## Product Change Notification / JAON-06SLTO183

CCB 4634 Final Notice: Qualification of MMT as a new assembly site for selected Atmel AT28HC256, AT28C256 and AT28BV256 device families available in 32L PLCC (11.5x14x3.37mm) package.

**CCB 4634**  
**Pre and Post Change Summary**  
**PCN # JAON-06SLTO183**

# Lead frame Comparison

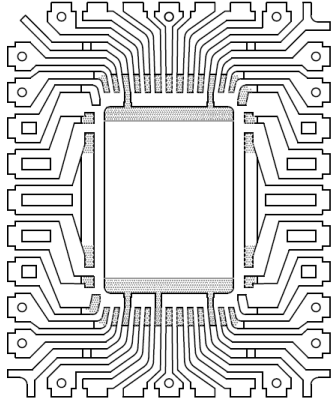
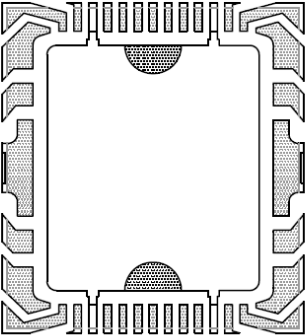
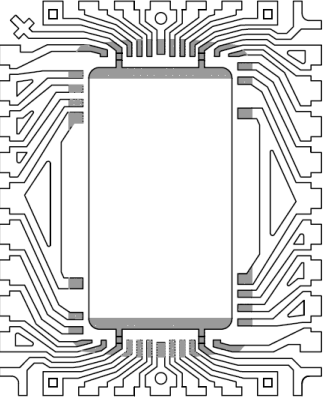
Pre Change		Post Change
LPI		MMT
 <p>PAD SIZE:181x261 MILS FUSED LEAD ON PIN#16</p>	 <p>PAD SIZE:225x260 MILS NON-FUSED LEAD ON PIN#16</p>	 <p>PAD SIZE:200x365 MILS NON-FUSED LEAD ON PIN#16</p>
